MEMORANDUM

To: Salt Lake City Planning Commission
From: Kelsey Lindquist, (801) 535-7930, kelsey.lindquist@slcgov.com
Date: September 11, 2019
Re: Ninth West Townhome Planned Development Time Extension Request

Re: Requested design and material changes for the Ninth West Townhomes Planned Development and Preliminary Subdivision Plat Petitions PLNSUB2018-00059 & PLNSUB2018-00223

To: Salt Lake City Planning Commission
From: Kelsey Lindquist (801) 535-7930
Date: June 13, 2018
Re: PLNSUB2018-00059 & PLNSUB2018-00223 - Ninth West Townhome Planned Development and Preliminary Subdivision Plat

FRONT ELEVATION SCALE: 1/4"=1'-0"

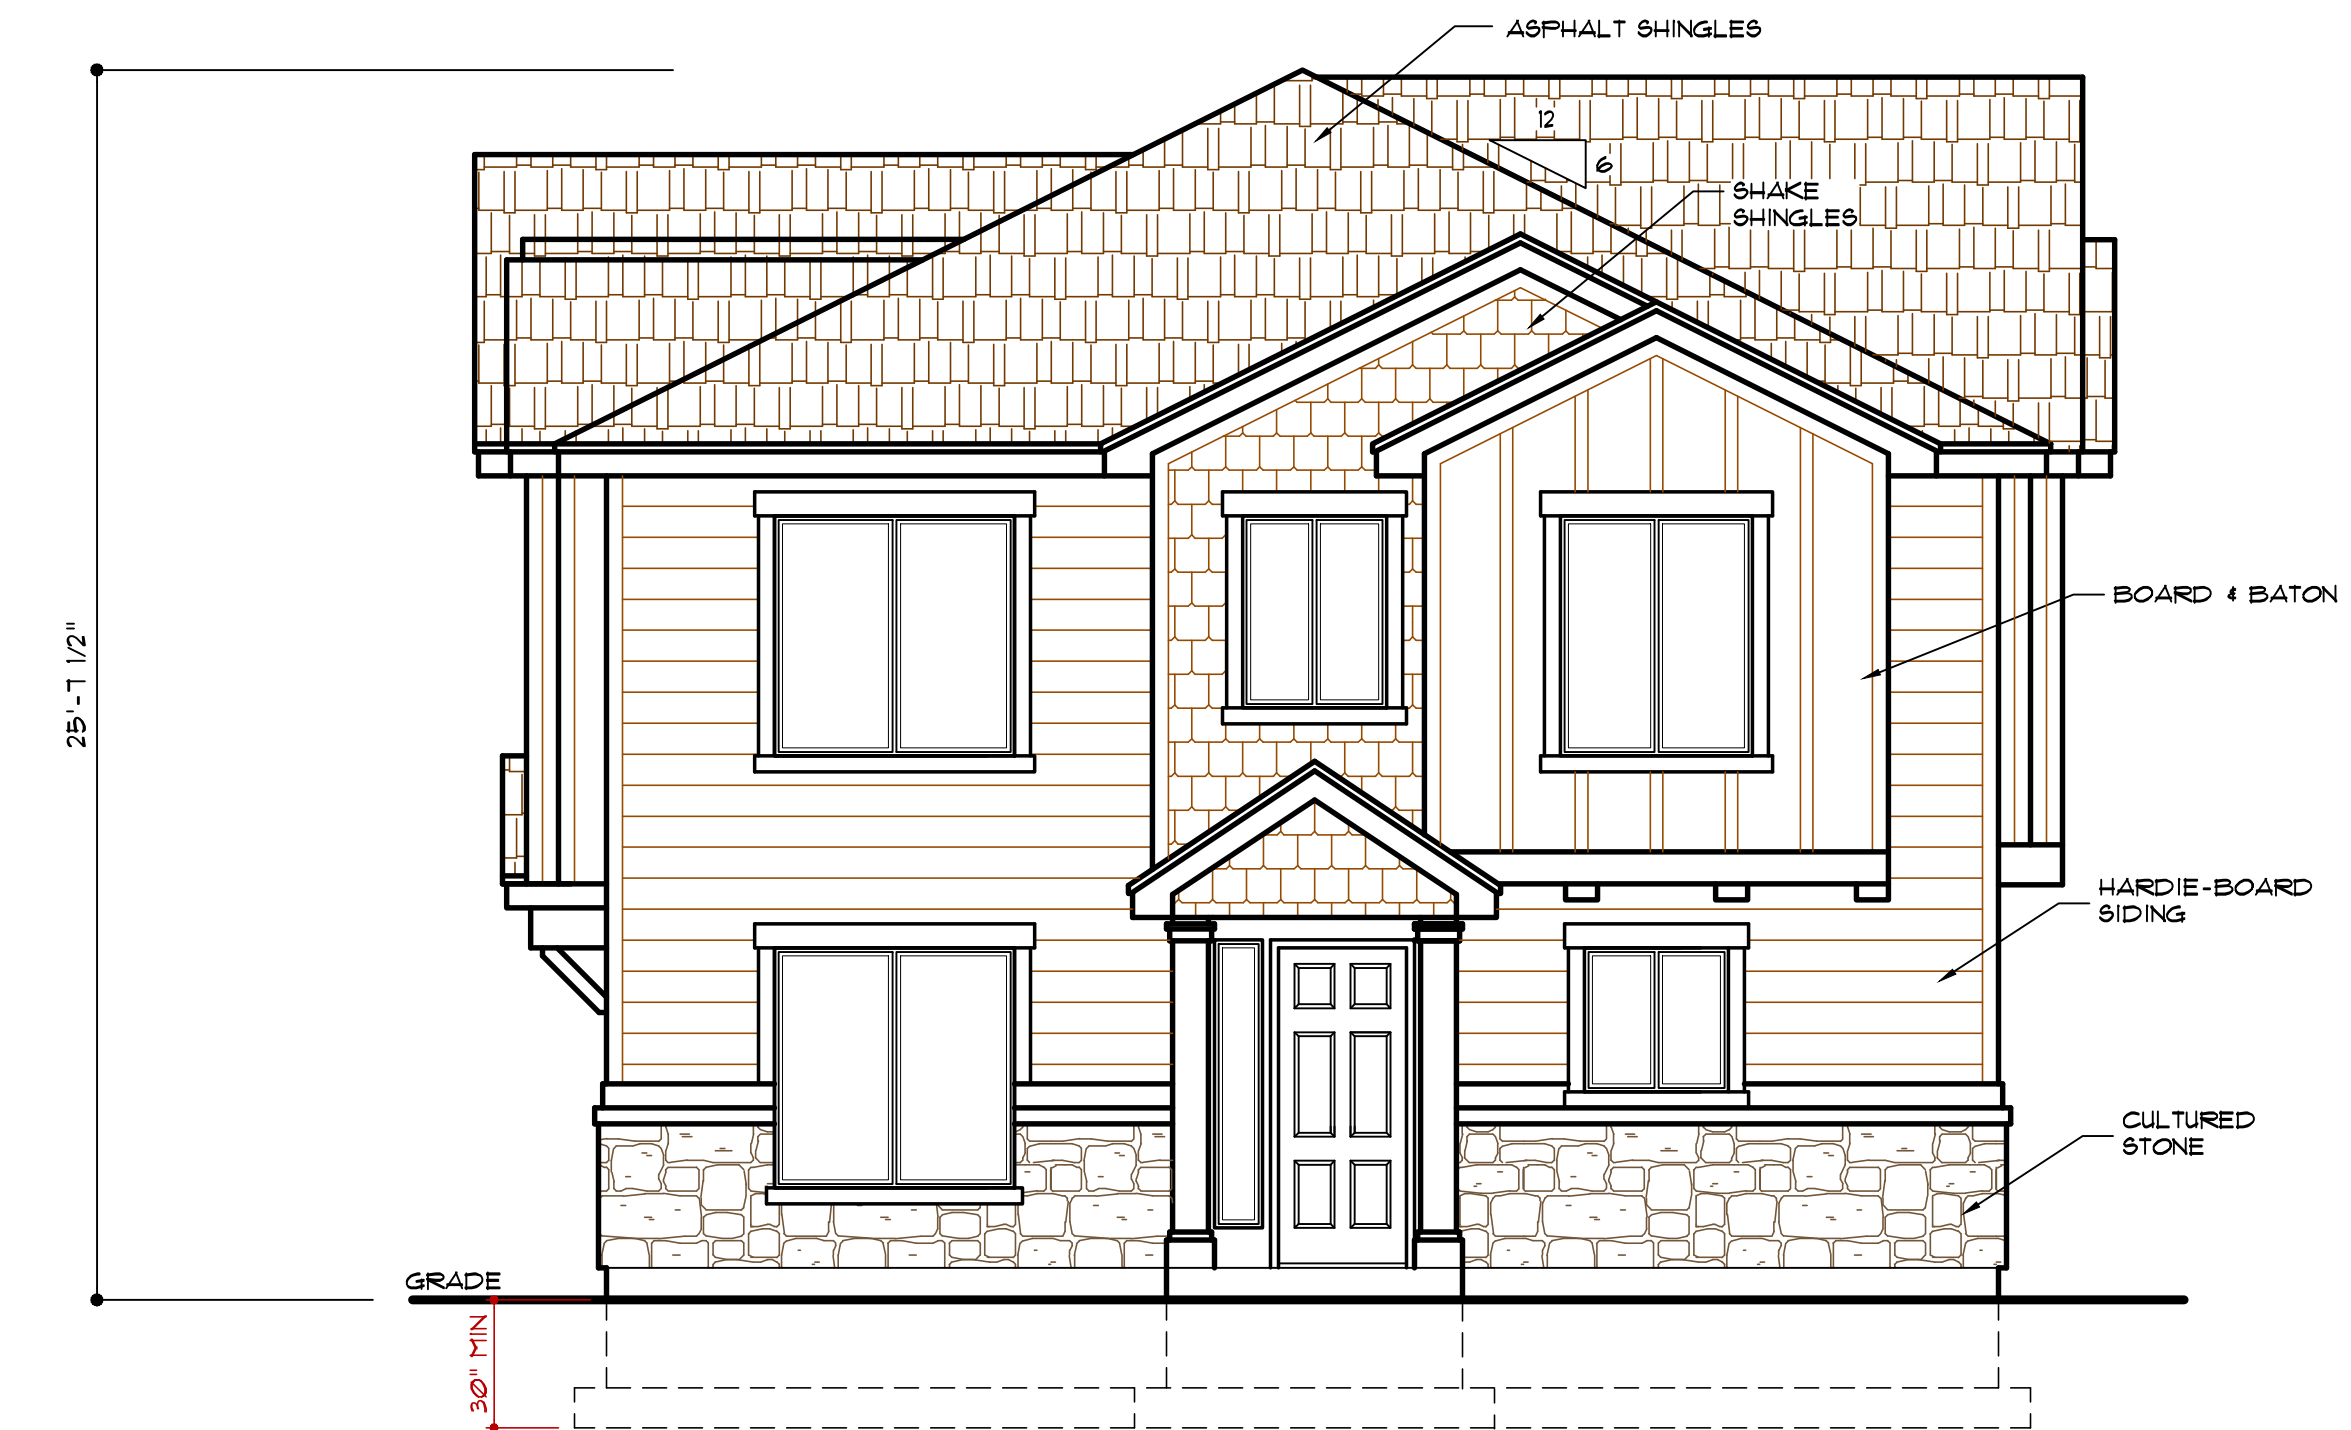
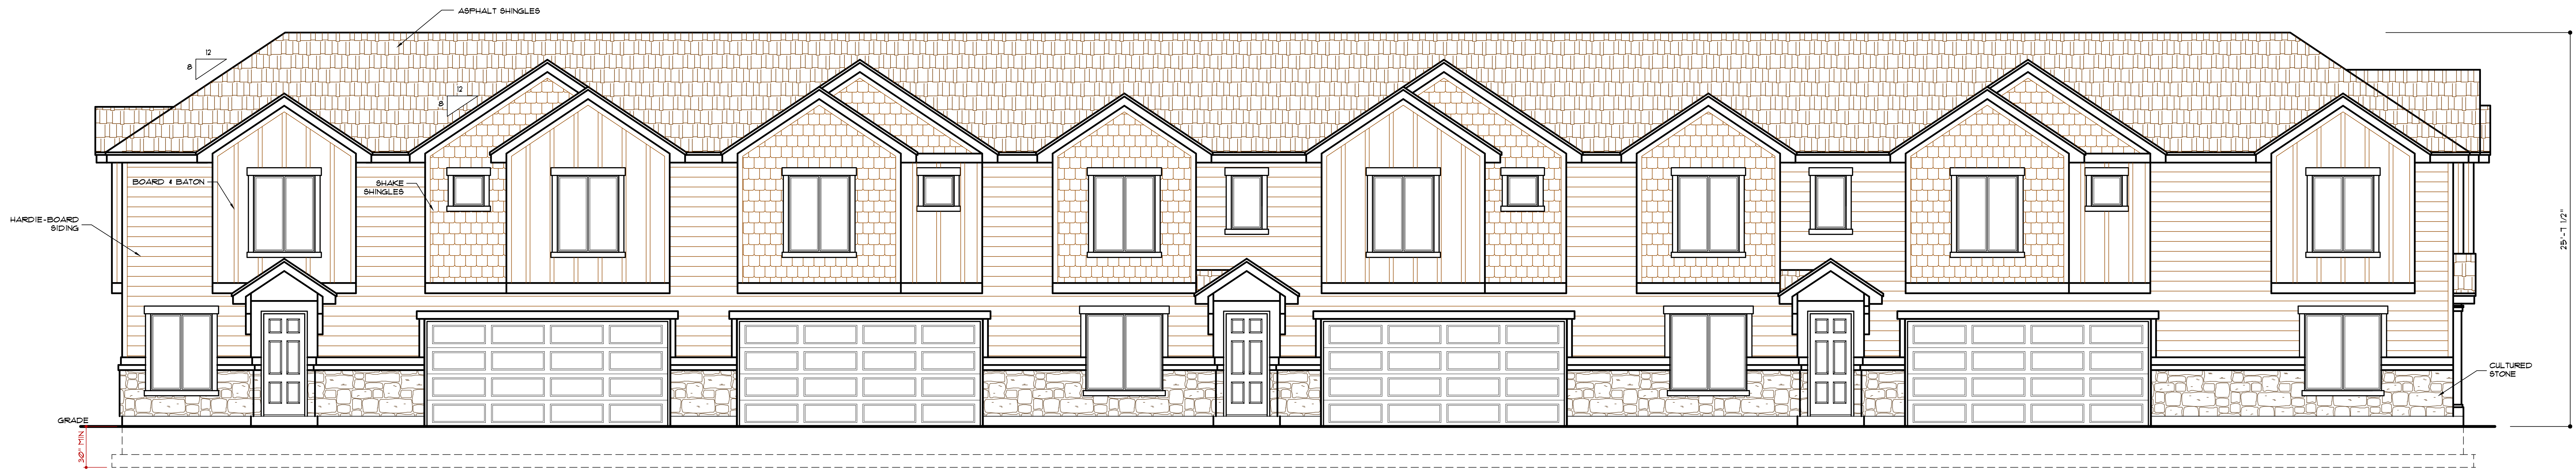
ACTION REQUIRED: Review the modification to the north and east elevations. The commission requested the alterations in anticipation of a final decision on the proposal.

1. Delineate each unit with alternating materials along the northern elevation;
2. Move the front door to unit one closer to the center of the eastern elevation;
3. Add a front porch element;
4. Windows should reflect a residential design.

Northern Elevation: The applicant revised the northern elevation to address the concerns regarding the use of stucco. The revised northern elevation illustrates the use of hardie-board siding, cultured stone and a gable roofed feature on the third unit.

Residential Windows: The east facing windows, which have not altered in style, flank each side of the entry way.

Revised Design

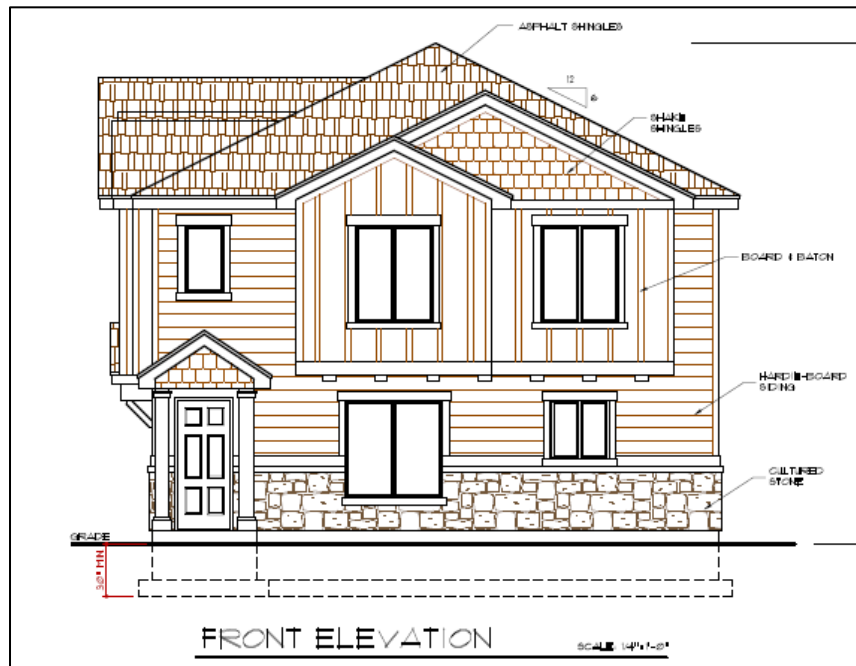
Initial Design
